MONTGOMERY COUNTY HISTORIC PRESERVATION COMMISSION
STAFF REPORT

Address:	7107 Carroll Avenue, Takoma Park	Meeting Date:	10/11/2023
Resource:	Contributing Resource Takoma Park Historic District	Report Date:	10/4/2023
Applicant:	Barrett Colombo (Richard J. Vitullo, Architect)	Public Notice:	9/27/2023
Review:	HAWP	Tax Credit:	Partial
		Staff:	John Liebertz
Permit Number:	1044477

PROPOSAL: Partial demolition, alterations to the rear enclosed porch including roof, fenestration, and materials, front porch alterations, fenestration alterations on the basement level, and tree removal.

Figure 4: View off the proposed front elevation (left) and columns from a 1921 trade magazine (right).

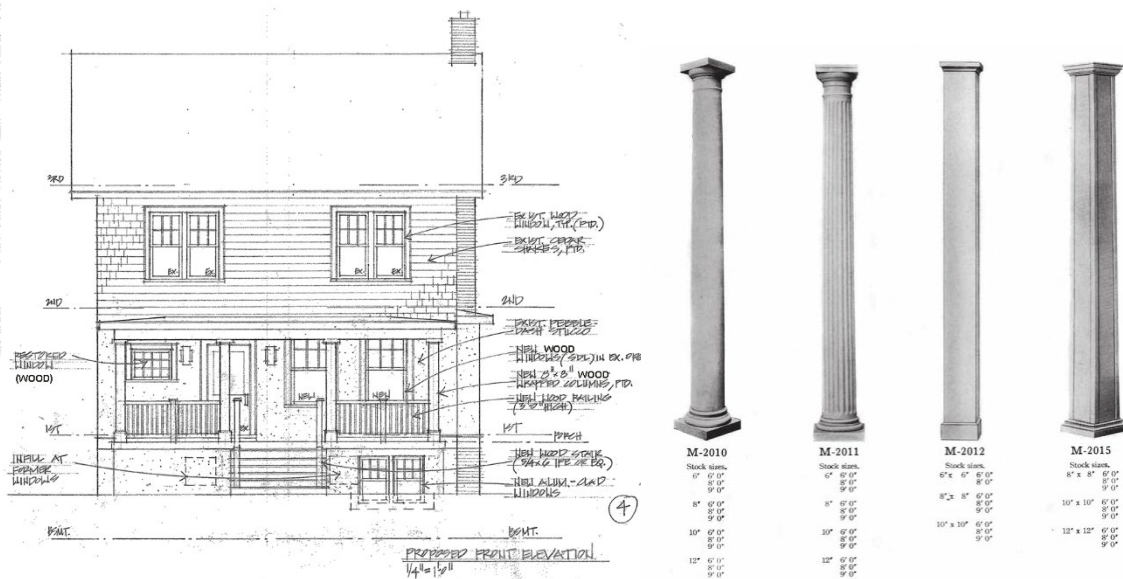
Staff finds that the proposed restoration of the front porch to be consistent with the applicable guidelines and recommends approval with conditions. Previous property owners enclosed the porch between 1962 and 1977. This included the installation of the asbestos siding, one-over-one, double-hung, wood-sash windows, and single-leaf, front door. Therefore, the removal of these non-historic materials would have no adverse effect to the individual resource or the historic district. The original configuration of the wood-frame porch, however, remains unknown. The porch likely had a pier foundation, tongue-and-groove wood flooring, wood columns or posts, porch balustrade, and stair, and a shed roof of a similar pitch. The proposed porch consisting of four posts, balustrade, and wood stair is consistent with other houses of similar design aesthetic and period of construction (*Figure 4*). Staff considered the appropriateness of square posts in lieu of traditional columns Doric columns, but confirmed the use of both types of materials in early twentieth century Colonial Revival dwellings (*Figure 4*). Staff requests that the applicant submit a detail for the design of the proposed post.

Staff finds the proposed restoration of the windows on the first story of the façade to be consistent with the applicable guidelines and recommends approval with conditions (*Figure 4*). The proposed six-over-one, double-hung windows under the front porch matches the original windows on other sections of the house. The windows would be installed within the original openings that presently hold non-historic, single-light, fixed windows. Similarly, staff recommends approval for the restoration of an infilled

window adjacent to the front door. The outline of the infilled window clearly is evident in the pebble-dashed stucco. The installation of a multi-light, fixed window at this location conforms with the design of the house. Staff requests that the applicant notes that all window trim is wood.

1. The applicant shall submit detailed drawings for the wood posts on the front porch.
2. The applicant shall contact staff during demolition of the front porch to review the three options for the front porch flooring. These options include:

3. The applicant shall include a note that all window trim on the first story of the façade is wood.
4. The applicant shall submit specification and detailed drawings for the proposed window wells and steel railings at the egress windows.
